AGENDA
MEETING OF THE
HIGHWOOD PLANNING AND ZONING COMMISSION

4.1 Petition for a Planned Unit Development from Allan Dennis, of Midwest Young Artists (MYA). The petitioner has applied to permit the use of vacant land, parcel #16-10-401-014 in Highwood IL, 60040 to be used as a concert hall and musical campus.

Subject: Resubmittal of Request for Zoning Change

Subject: MYA Campus Expansion
Conceptual Plan #2
(CBBEL Project No. 170196.R2301)

CONCEPTUAL PLAN #2

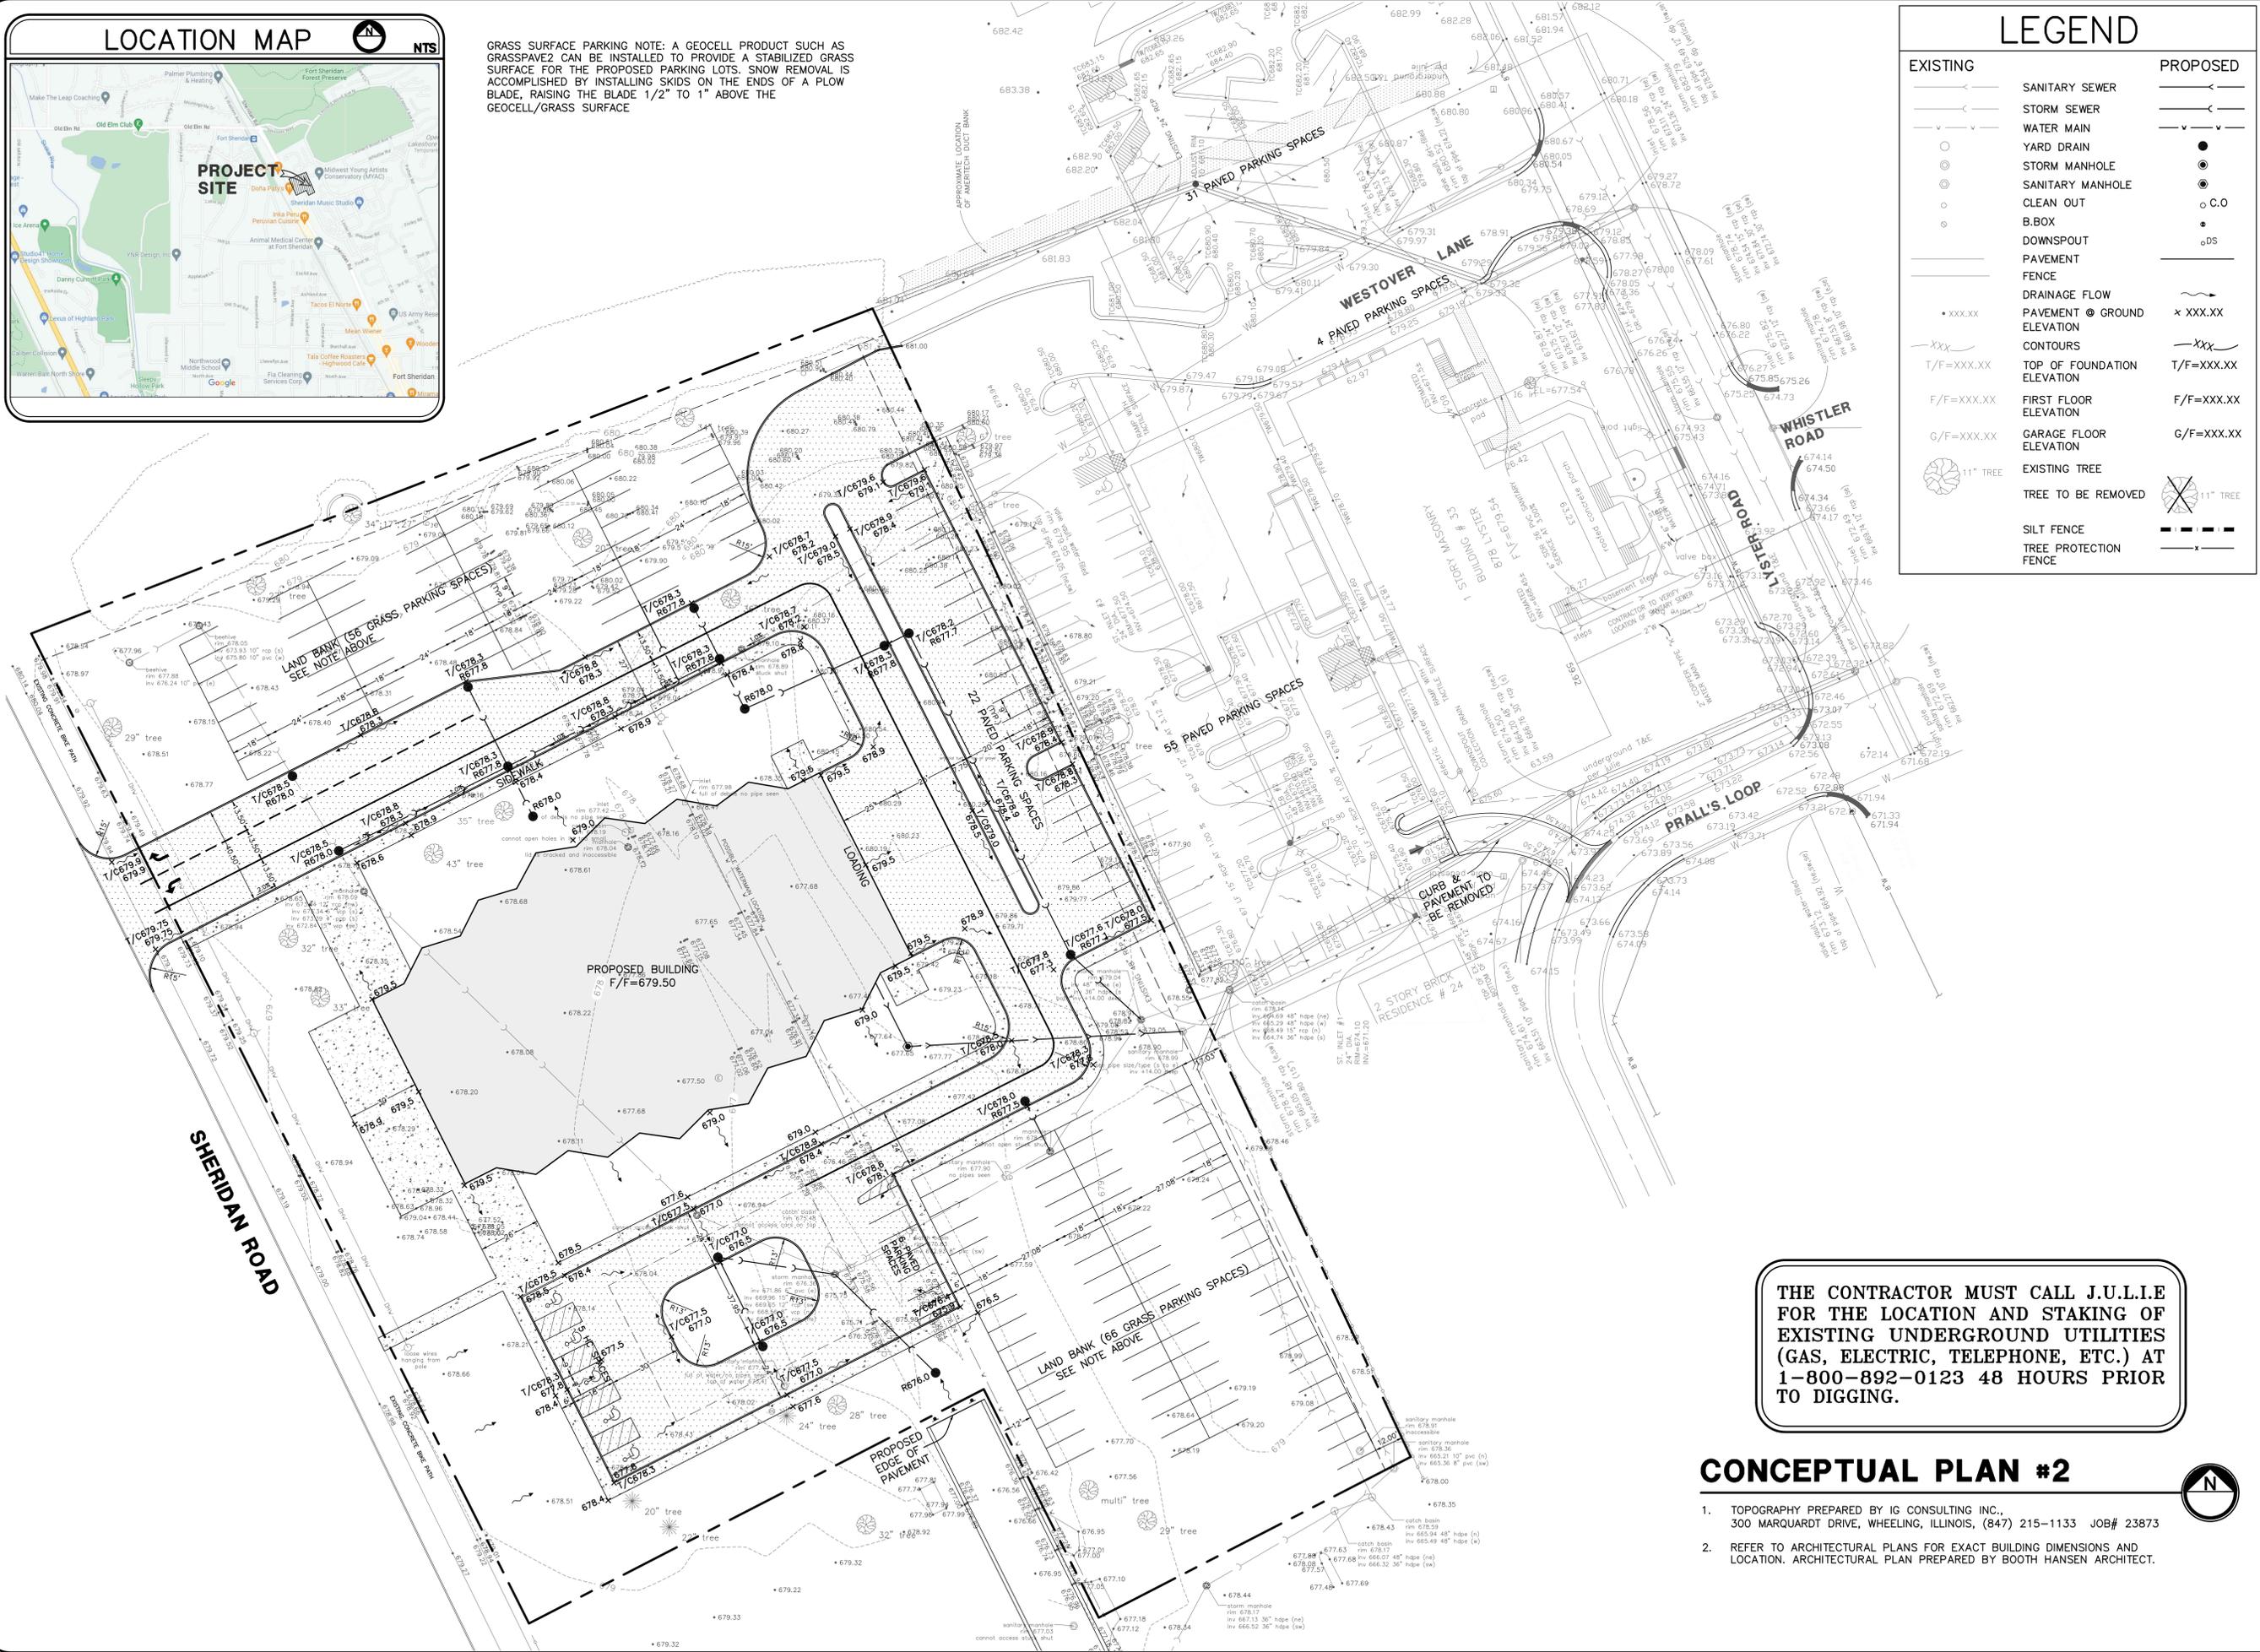
1. The traffic impact study (TIS) and large event parking plan are acceptable.
2. We find the Concept Level Engineering Plans to be generally complete and acceptable for concept level plans.

3. A Watershed Development Permit is required if more than 3 acres of land is hydraulically disturbed. Please refer to Article 3.300.06 of the Lake County Watershed Development Ordinance. This shall be submitted with final engineering plans. Based on our discussions and supplemental information provided, there is an agreement that the final design will be in full compliance with City and Lake County codes and stormwater detention will be provided on site. Several alternatives are being considered for stormwater detention storage, including but not limited to, an underground stormwater vault or chambers, and the release of stormwater will be restricted as required.. We understand that the City will not issue development permits until final engineering plans and reports provide documentation that the proposal is in compliance with City and County codes. The proposal will not include storage within the existing regional stormwater basin east of the site.

3. With final engineering plans all City utilities along Westover Road shall be shown as either re-routed or removed. This will also include any utilities shown running under the proposed building.

4. A Watershed Development Permit is required if more than 3 acres of land is hydraulically disturbed. Please refer to Article 3.300.06 of the Lake County Watershed Development Ordinance. This shall be submitted with final engineering plans.

9. The plans show the parking lot exit onto Prall's Loop as being removed. This shall be included in the final engineering submittal with more detail.

10. The existing depressed curb on the north side of Westover Road on the south end of the project shall be shown as removed and replaced with barrier curb consistent with the adjacent subdivision.

Response: Westover Road to be removed is within the MYA property and not in a public right of way. Therefore, a Plat of Vacation would not be necessary.

Response: All necessary removal or re-routing of Westover Lane utilities, including utilities under the proposed building, will be indicated in the final engineering drawings. Easement will be created where necessary.

Response: As we have reviewed together, we have developed a preliminary storm water management concept to include a chamber or vault system on the site to restrict the release of on site storm water runoff. The Offsite Basin will not be used for the project stormwater management. A watershed development permit application will be completed and submitted with final engineering drawings.

Response: Fire hydrants are shown. Locations will be designed based upon a 400-foot radius of protection. Please see our revised exhibit depicting a proposed water main and fire hydrant.

Response: Details for the permeable Geocell product will be provided in the final engineering submittal.

Response: A detail shall be provided for pavement removal and restoration, to close Westover Lane at Lyster Road, as well as Westover Lane at the south end of the site. Dead end signage will be provided at the south end of Westover Lane.

Response: In final engineering, additional details shall be provided for removal and restoration of the parking lot exit to Prall's Loop.

Response: Barrier curb shall be indicated, where Westover Lane will end at the south end of the site.
